Please add to file 2025-07-044

**From:** Ashley Dopart <[ashleyd@northeastengineers.com](mailto:ashleyd@northeastengineers.com)>  
**Sent:** Friday, September 19, 2025 9:54 AM  
**To:** Anthony Sawaia <[asawaia@crmc.ri.gov](mailto:asawaia@crmc.ri.gov)>  
**Cc:** Isabella Ehrlich <[isabella@milkandhoneygroup.com](mailto:isabella@milkandhoneygroup.com)>  
**Subject:** 10 Minnesota Rd 2025-07-044

Drawing Title:																																																									
<b>SAV SAMPLING GRID</b>

**Re: 10 Minnesota Road, Little Compton, SAV**

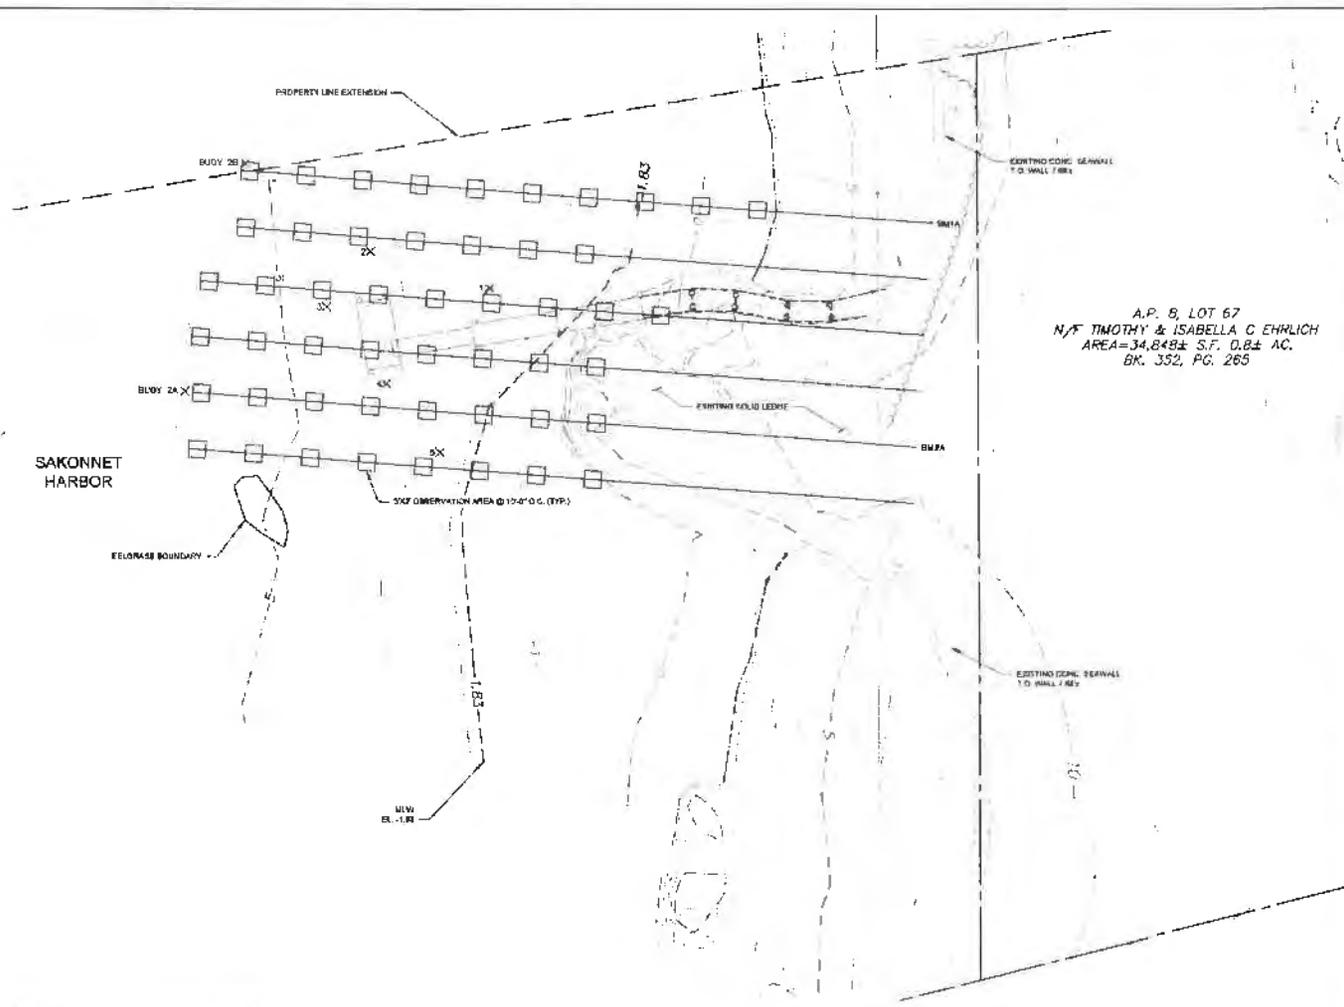
Who performed the SAV survey? Usually the surveys show pictures and document that none were there. If you could submit that that would be helpful. I want it for this area because the surrounding area has been known to have SAV.

And our engineers reviewed the plans and wanted clarification of the process with the piles on the ledge with the steel plates and epoxy grout etc. I think they were just looking for a quick explanation as you just gave. I will see if this clarifies more for them and if you could provide proof that no SAV is within the dock footprint that would be enough.

My survey crew and I completed the bathymetric survey in the waters off the above referenced lot in April of 2025. During the completion of this survey, I discovered that the entire area in the vicinity of the proposed pier and float consists of ledge and large boulders. Since this habitat isn't conducive for eelgrass growth, my engineers proceeded with the design and permitting of the proposed pier and float. You recently asked if NEC had any further eelgrass investigation documentation or underwater photos. To err on the side of caution, I performed a submerged aquatic vegetation (SAV) survey, with photos, on September 23rd and 24<sup>th</sup> of this year.

The attached plan entitled, "SAV Sampling Grid" was used, in conjunction with the benchmarks and buoys set to locate the test area. The referenced plan shows that the site was divided into transect lines that were spaced at ten-foot intervals. Each transect line was then followed and the bottom was observed with the assistance of dive equipment. The entire length of the transect line was observed and the bottom cover recorded every ten feet, as recommended in RICRMP section 300.18. No eelgrass was found in any form or density. The entire area was ledge, large boulder, and cobble, covered primarily with rockweed. Photos of the bottom were taken and are attached. Also, the plan includes photo locations.

The area surrounding the sample grid was then observed. One small area of eel grass was observed southwest of the proposed float, totally covering a small section of sand/ mud bottom that was surrounded by boulders. The limits of the eelgrass was surveyed, and is shown on the project plans. A larger section of eelgrass was also found 75' to the west of the proposed float, this appears to concur with the eelgrass previously mapped by CRMC.
